To: David Hollis
From: Jeff Walton, Associate Planner; 910-341-3260
CC: File;
Date: 10/16/2013
Re: Planning Comments

Site Plan Comments:

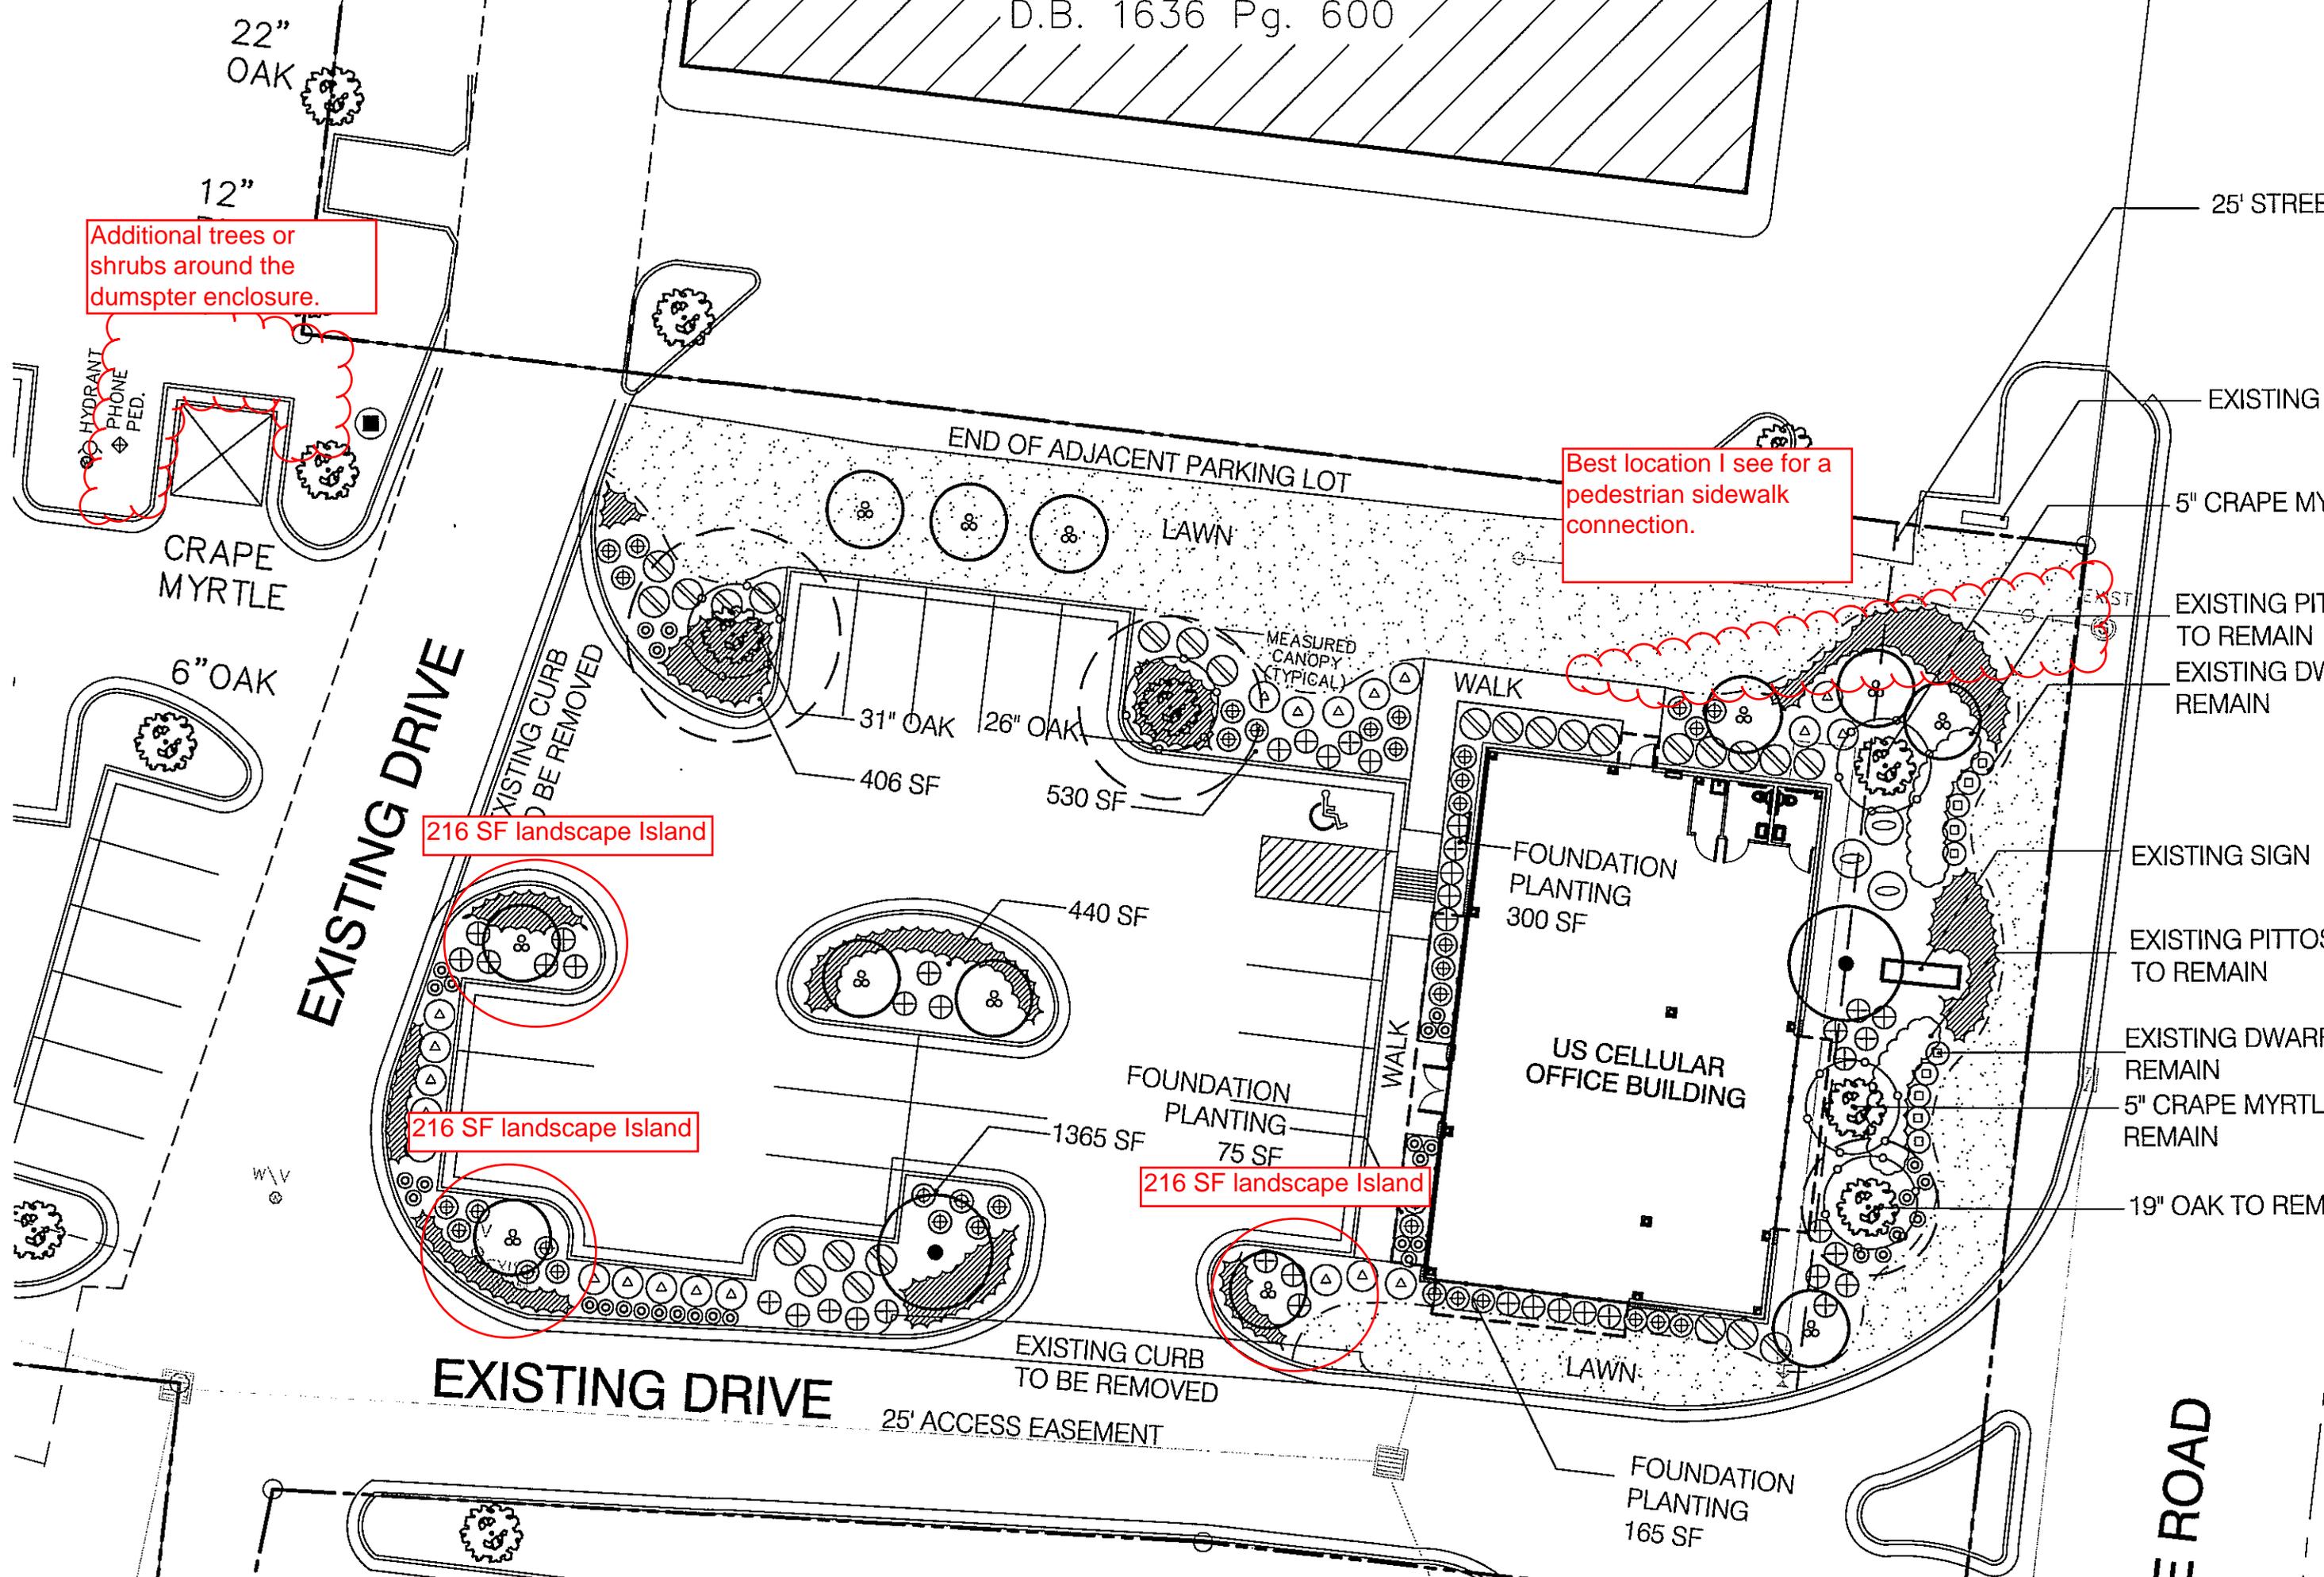
- Please show SF of all landscape islands, I have attached a redline of my comments.

Additional trees or shrubs around the dumpster enclosure.

Best location I see for a pedestrian sidewalk connection.

216 SF landscape Island

216 SF landscape Island

216 SF landscape Island

216 SF landscape Island
